Portland General Electric Company

Trojan ISFSI
71760 Columbia River Hwy
Rainier, Oregon 97048

VPN-009-2019

Submittal of Response to NRC's Request for Additional Information
Related to the Trojan ISFSI License Change Application (LCA 72-07) for
License Renewal (CAC No. 001028)

FIGURE 1.3.6

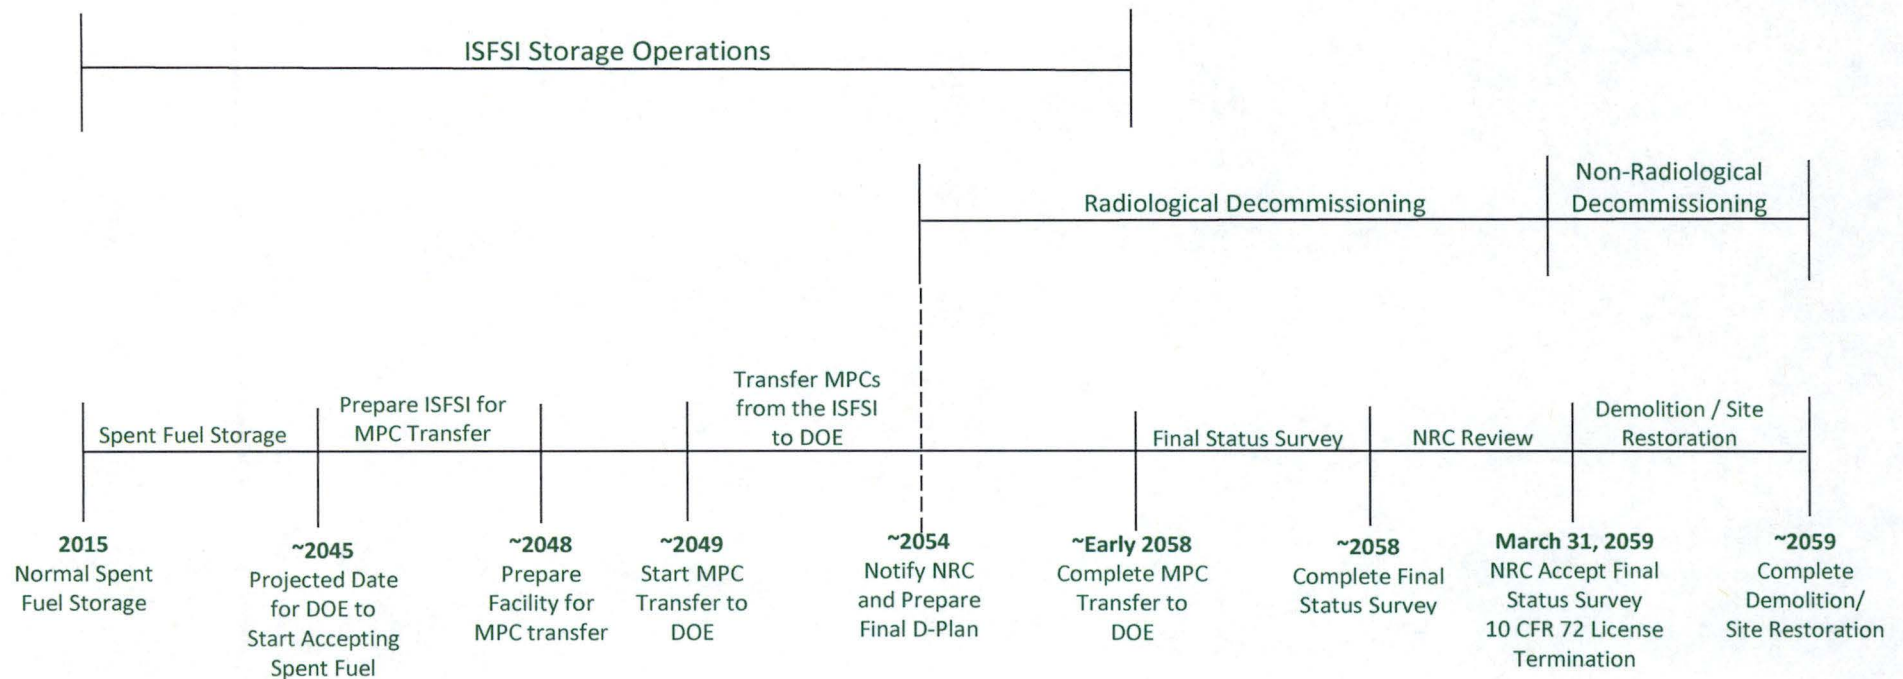
This supplement adds a new Figure 1.3.6, titled "Trojan ISFSI Estimated Project Timeline with Projected March 31, 2059 License Termination Date." This figure provides the general projected timeline for Trojan ISFSI activities that occur during the extended license period.
